PARKLANDS VILLAGE 2 PHASE 2

DATE:
06/07/2023 SITE PLAN 01

SHEET TITLE:
LANDSCAPE
PLAN

PARKLANDS VILLAGE 2 SUBDIVISION FILING NO. 2

2 FREE STANDING CONCRETE PLAYGROUND CURB

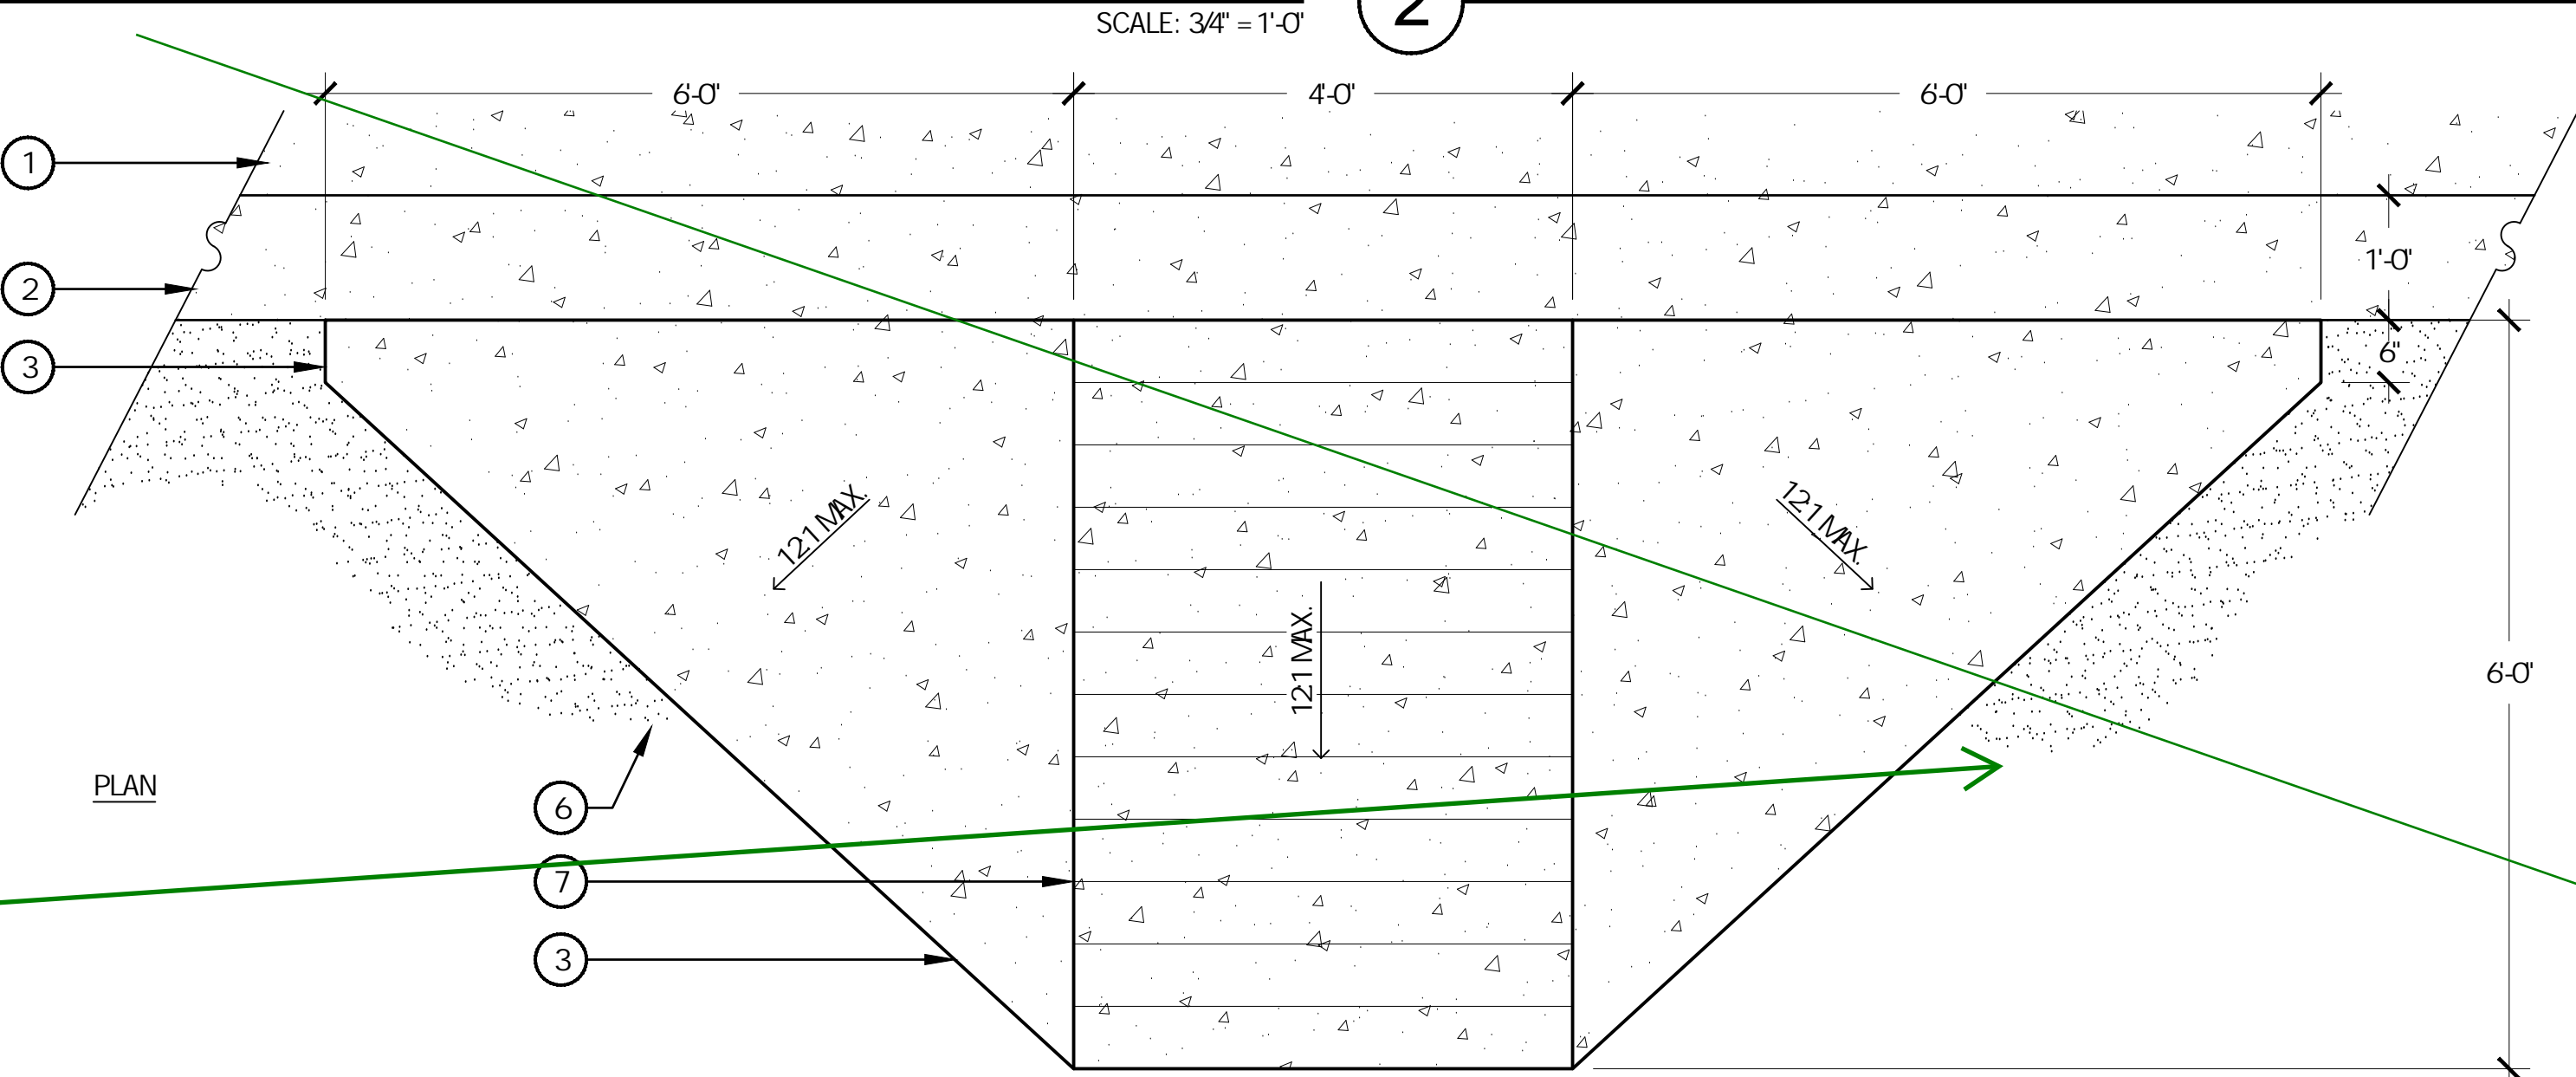
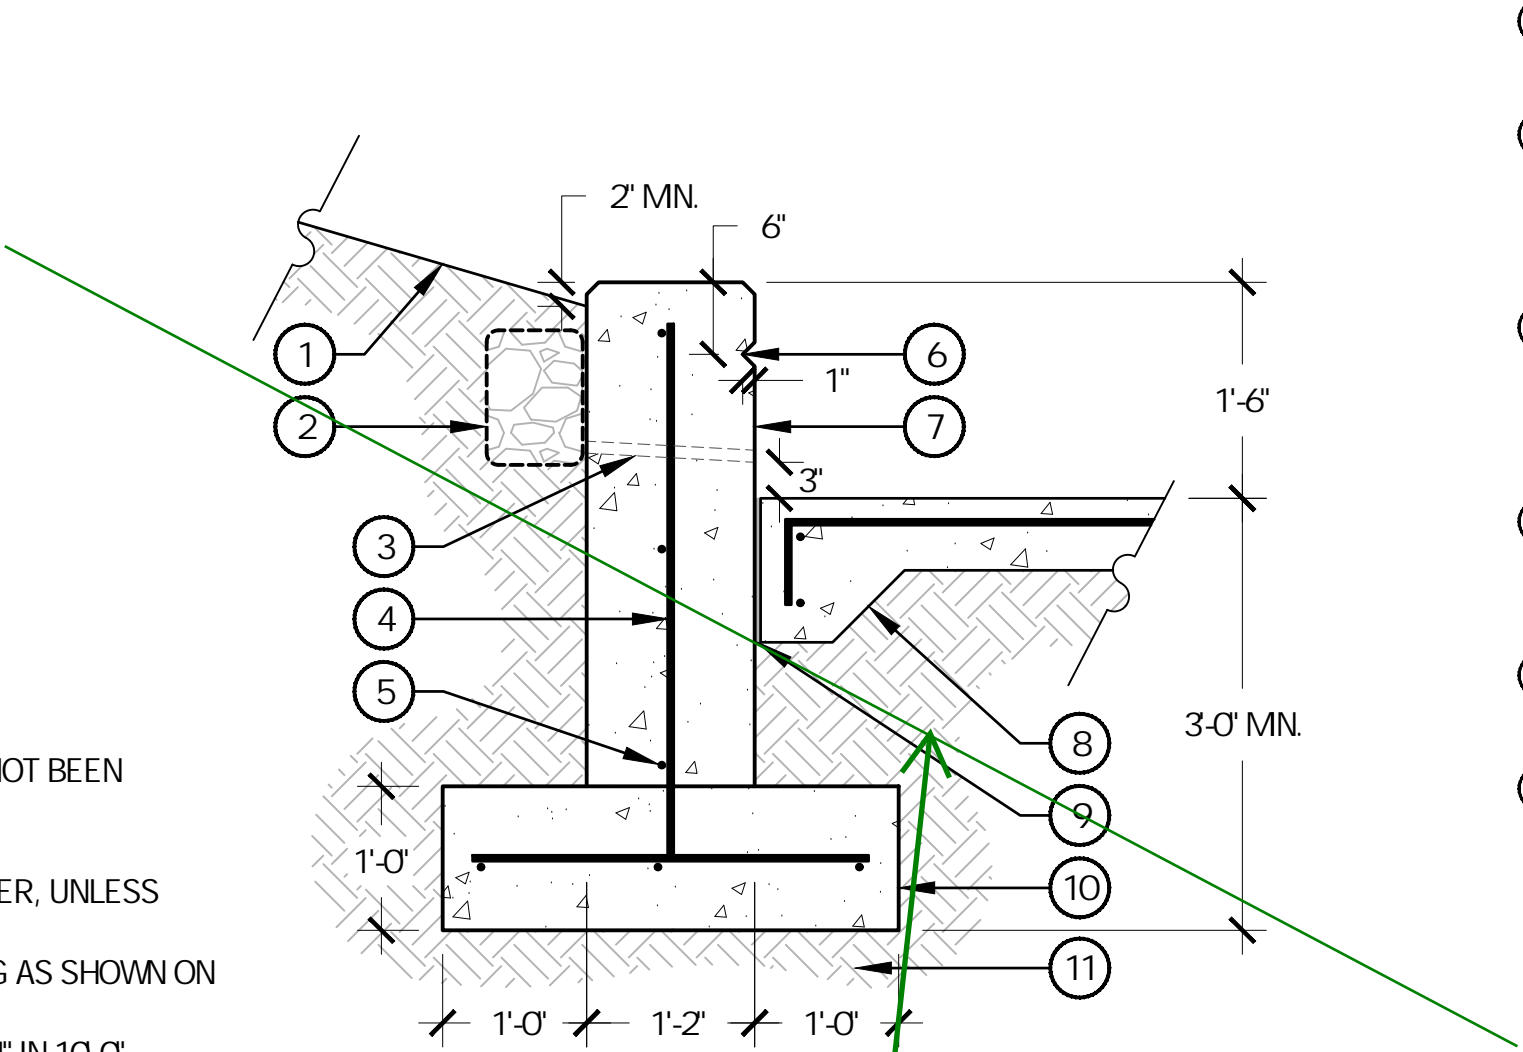
Please remove these details from the site plan, and only include this level of detail on the civil plan submittal.

Details have been removed.

6 SHADE STRUCTURE

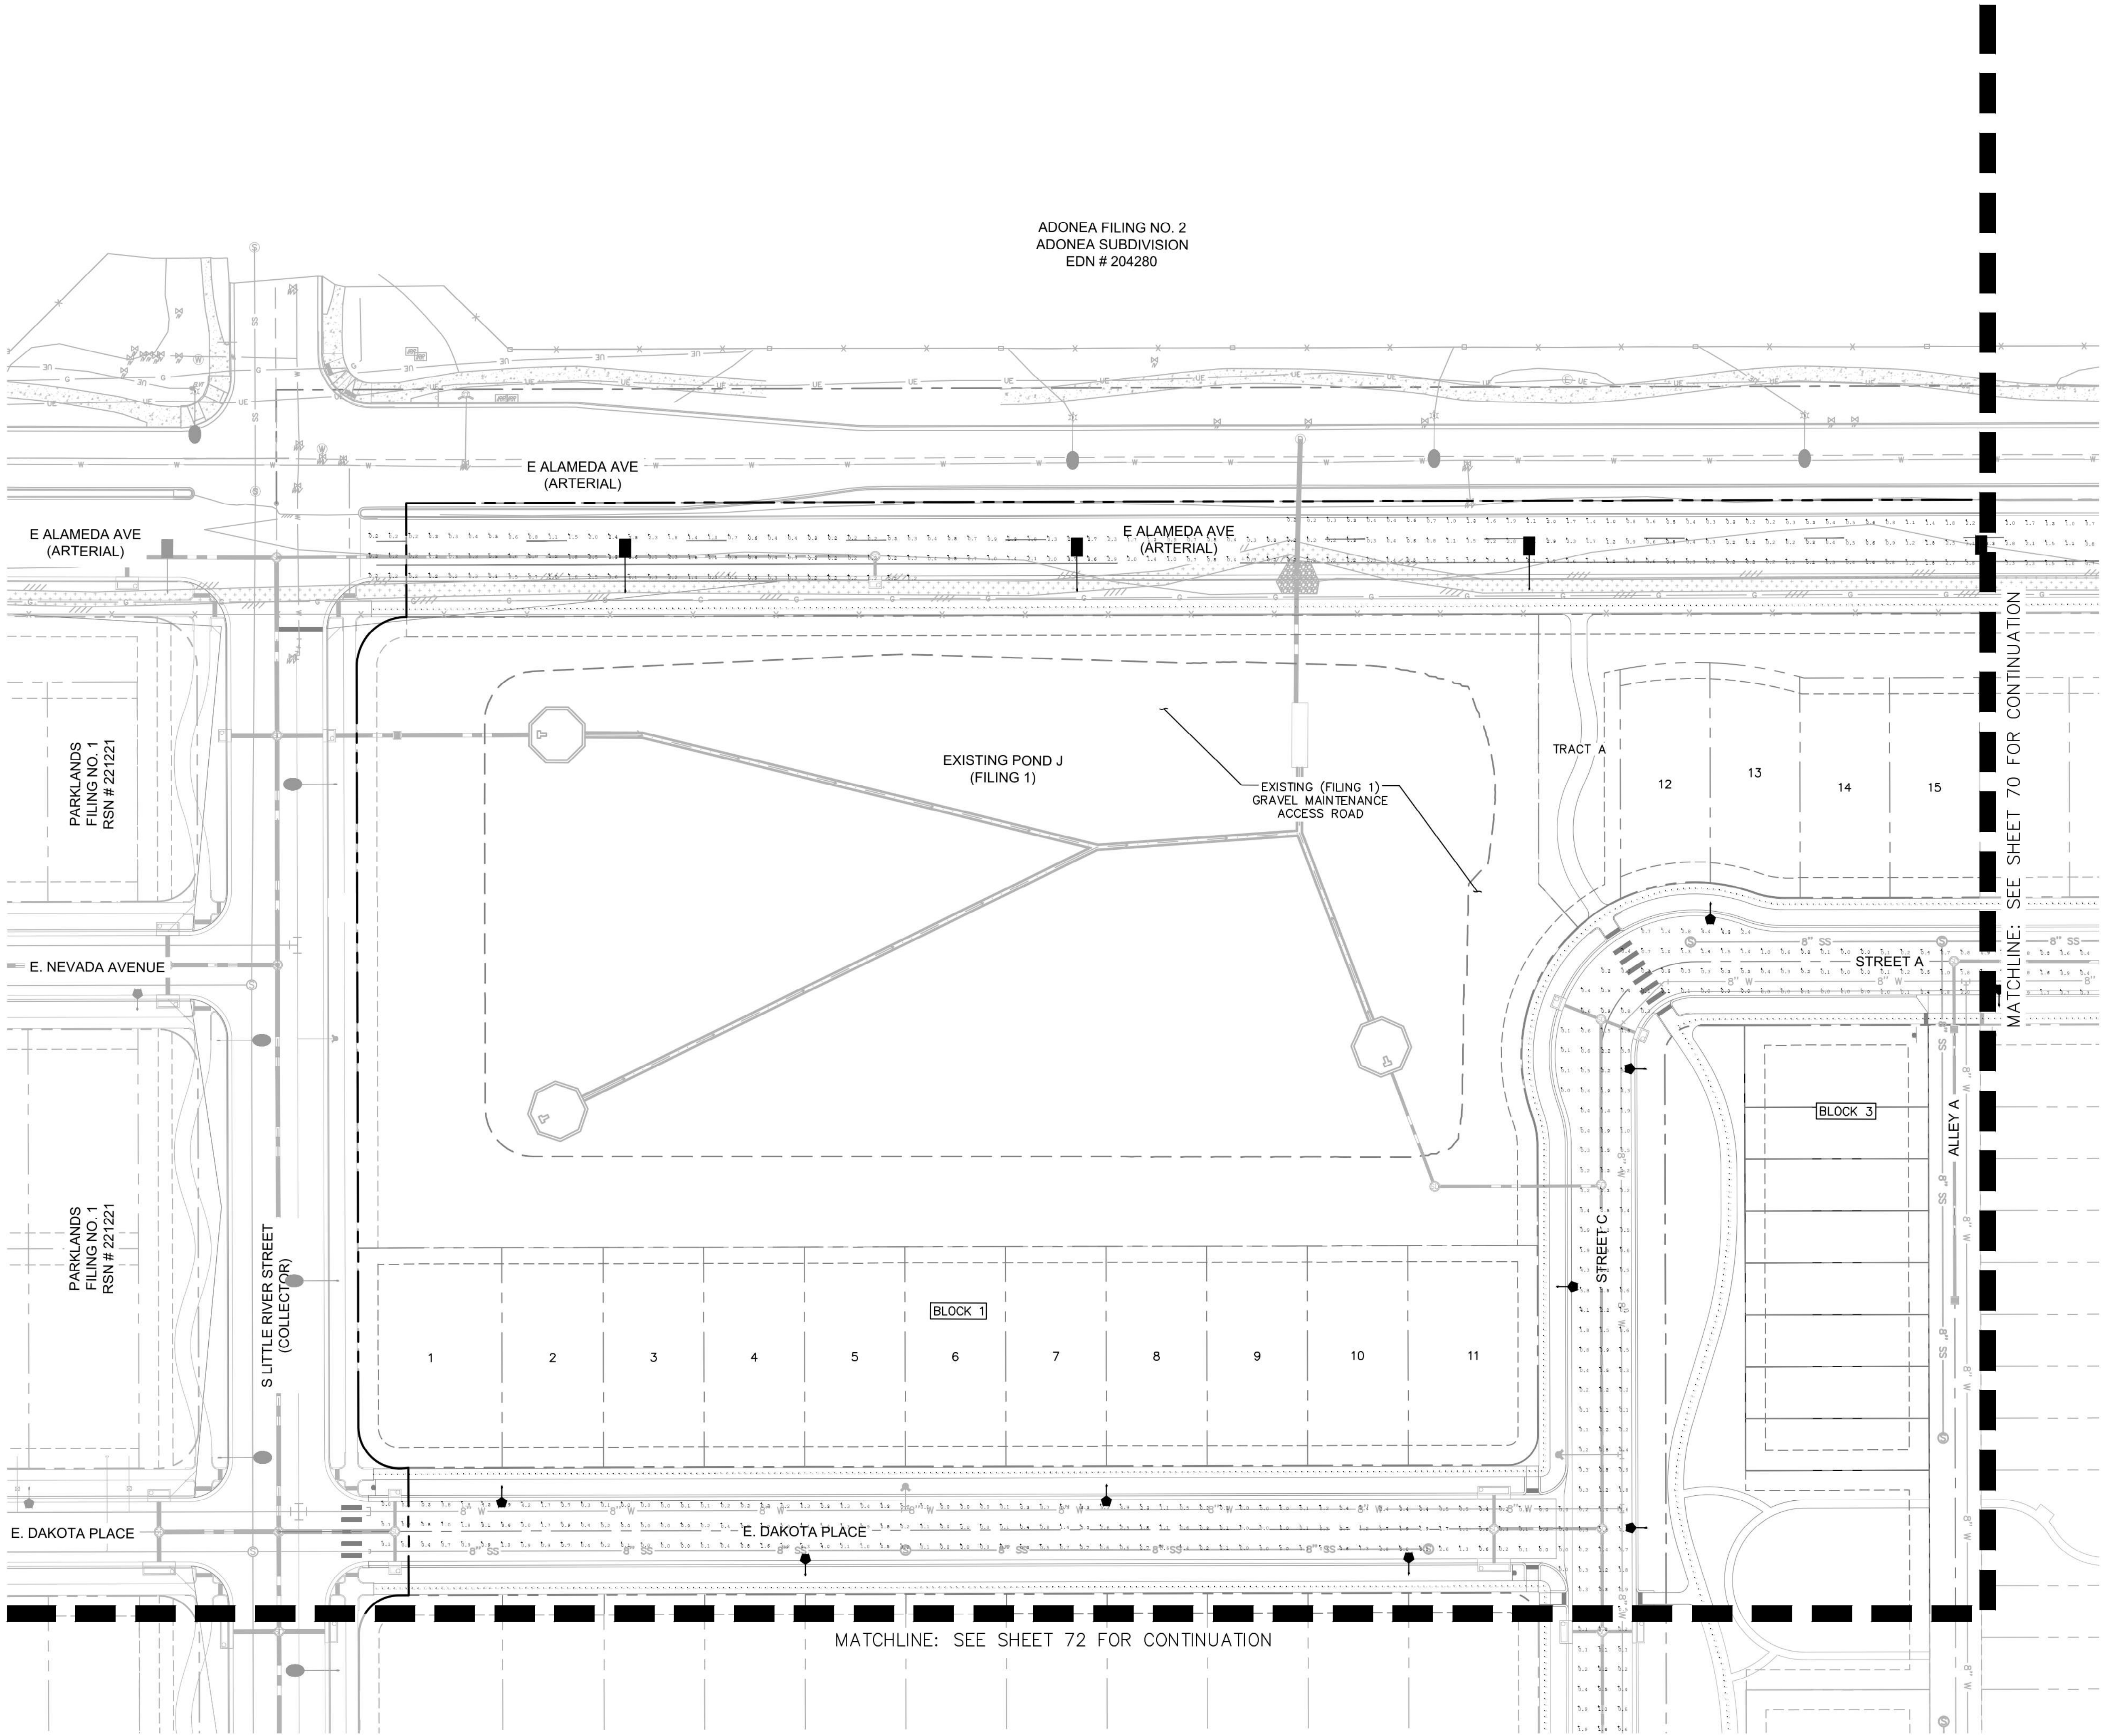
Please correct the typo to "polygon"

Polygon is the company name. Spelling is correct.

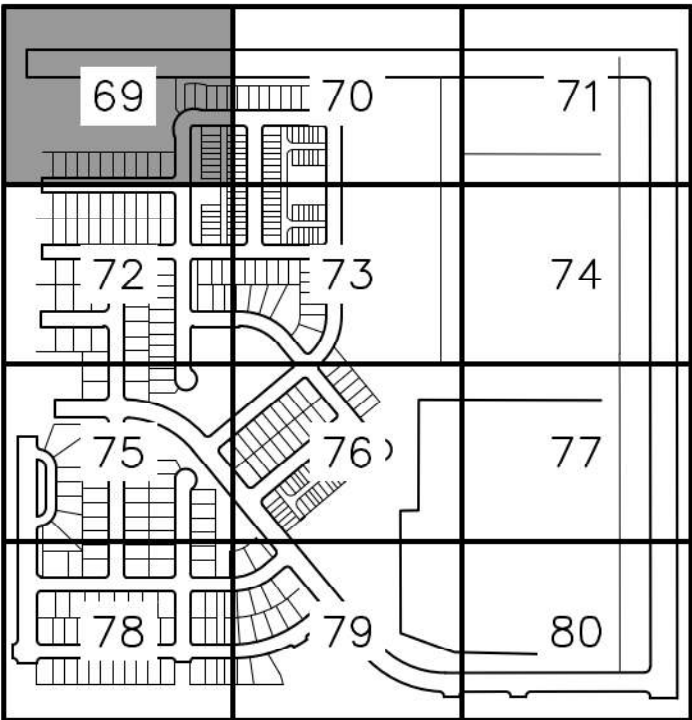
Show and label accessible route(s) on all photometric sheets.

The photometric plan must show and label the location of the internal site accessible route. Provide a minimum of 1 foot-candle of lighting within the accessible route.

SHEET 4 OF 13

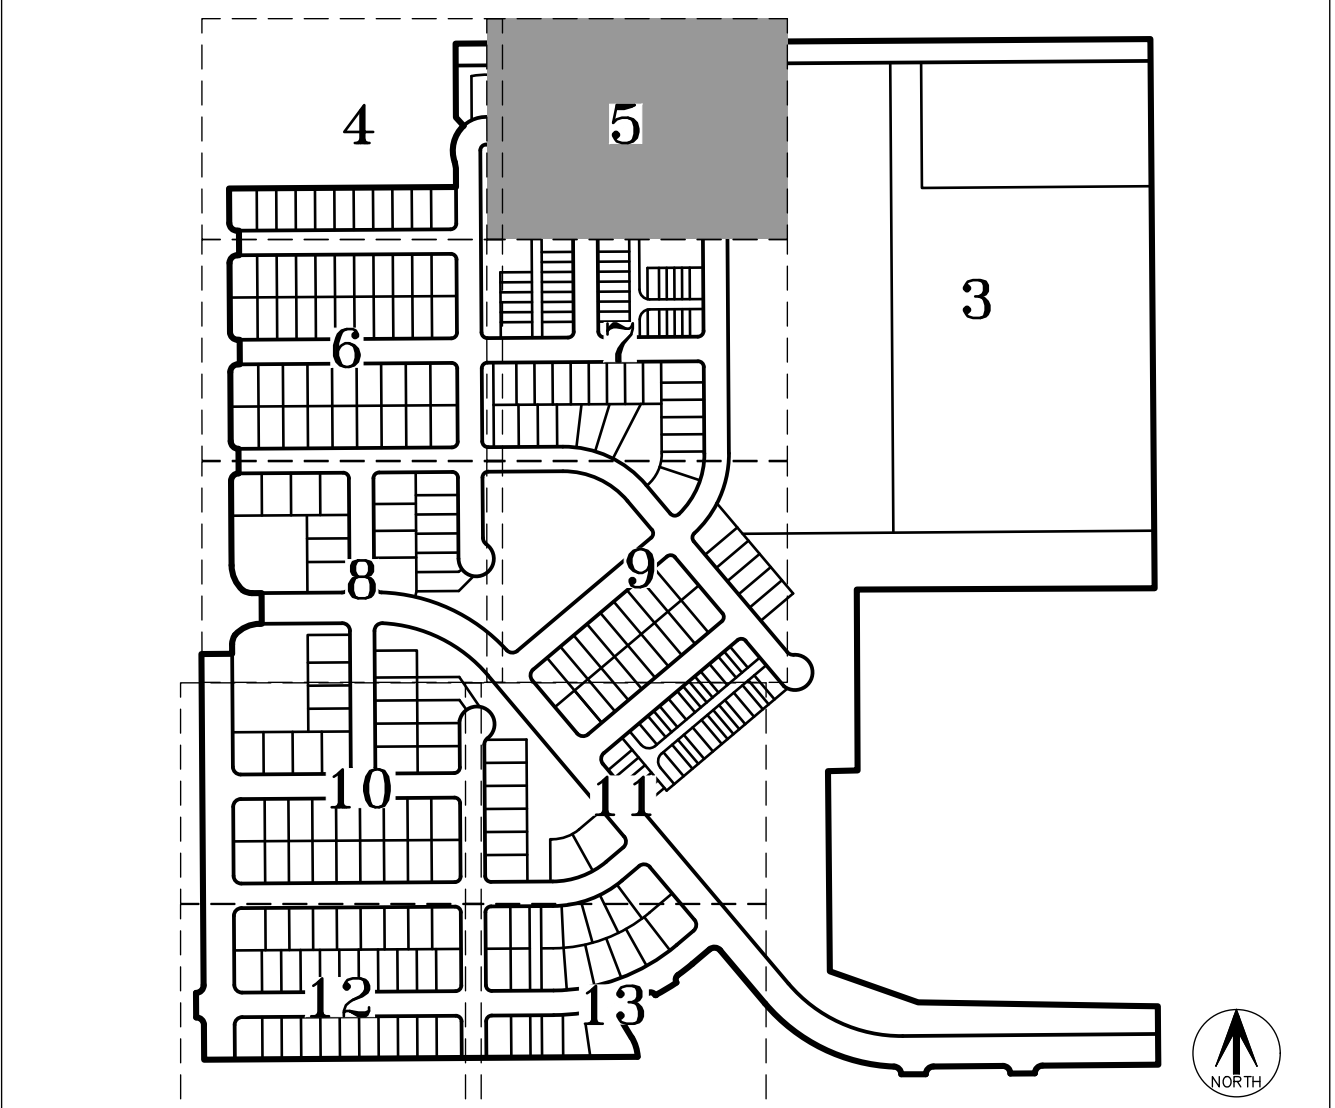
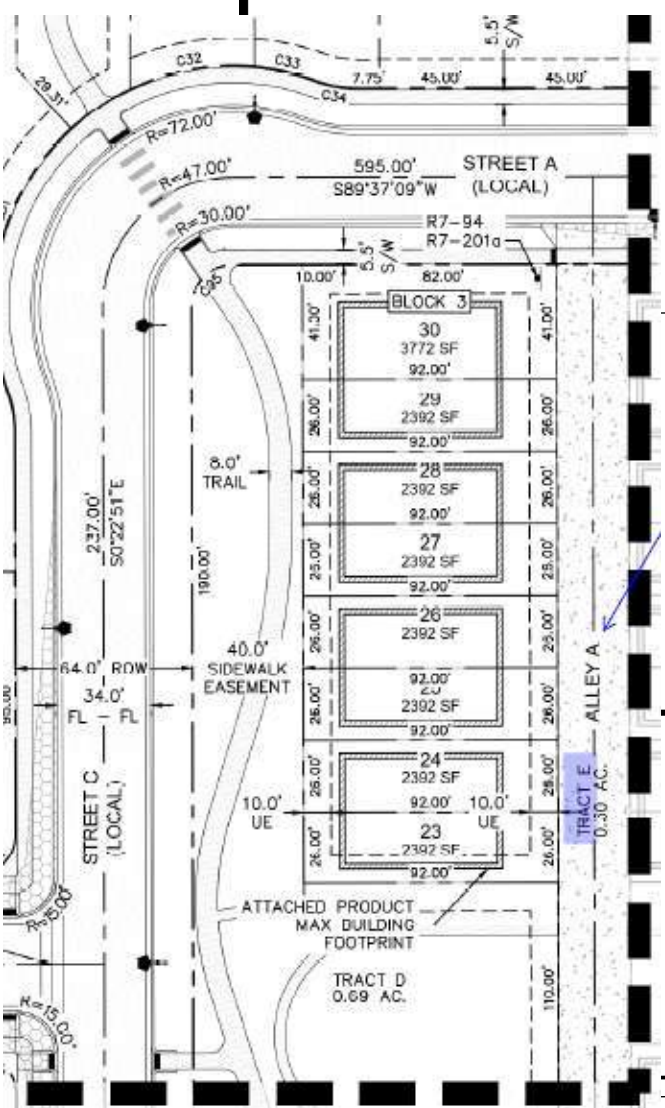
change this to be a
6' Gas Easement &
4' U.E. (typ.)

change this to be a
6' Gas Easement &
4' U.E. (typ.)

add the centerline bearing
and distance between the
pins - add interx pin
added info
